RE: **Review of LANL's November 1993 Installation Work Plan for Environmental Restoration, Revision 3**

SUBJECT: **Review Of LANL's Installation Work Plan for Environmental Restoration, Revision 3 submitted November 1993.**

Figure G-1. Generalized decision diagram of the observational approach.

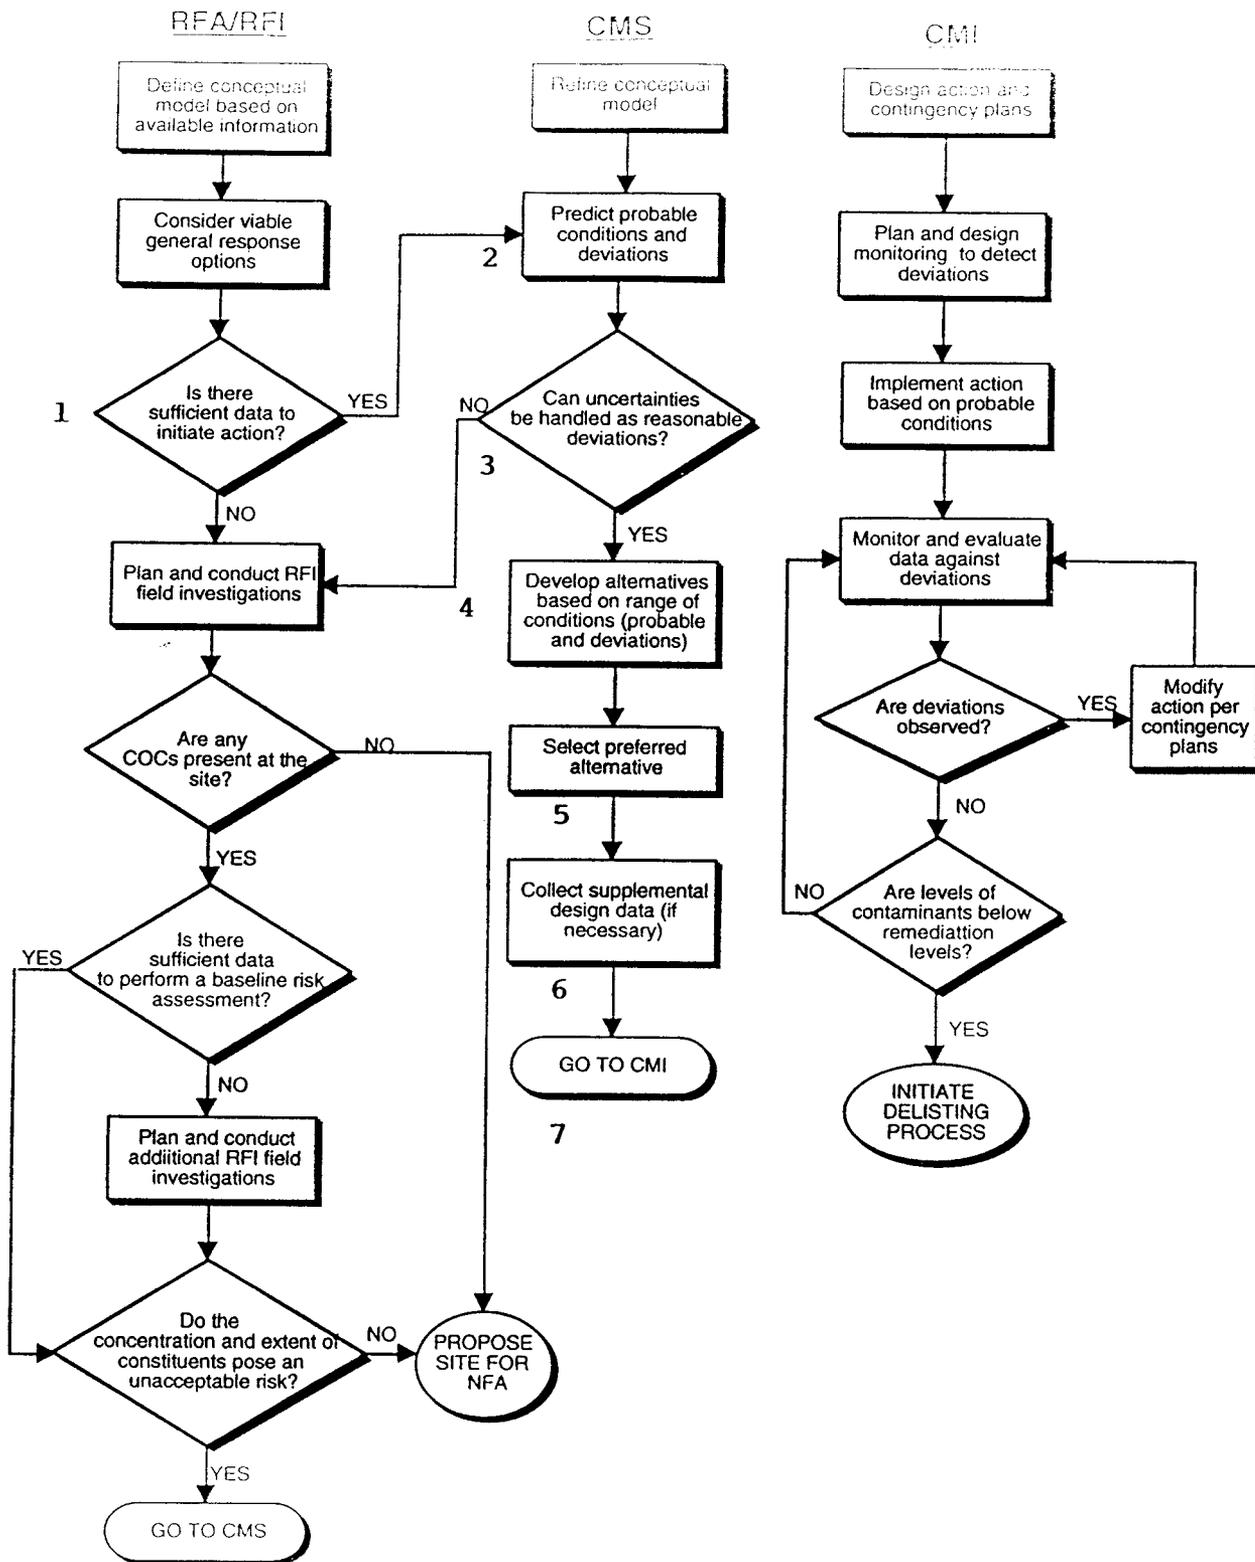
12. (Appendix G,p.G-3fG-1) Here too the decision diagram steps numbered 1-7 would seem to describe the VCA process as a standard practice when "there is sufficient data to initiate action". Is this the case?

15. (Appendix G,p.G-10p2) No mention is given to determining the long-range (e.g., 10,000 year) integrity of the unit.
16. (Appendix H,p.H-3b1) What are 'temporal boundaries'?
17. **GENERAL** With regard to the use of SAL's for indication of a release from a unit, as well as regarding their use in determinations of extent of contamination, it should be explicit in the IWP that when more than one COC is present at a site the risk assessment will be conducted using the cumulative hazardous and toxilogical effects of the constituents present, even when the concentrations of individual constituents do not exceed SAL's.
18. (Appendix I,p.I-3fI-1) It is difficult to reconcile this figure with Figure G-1.
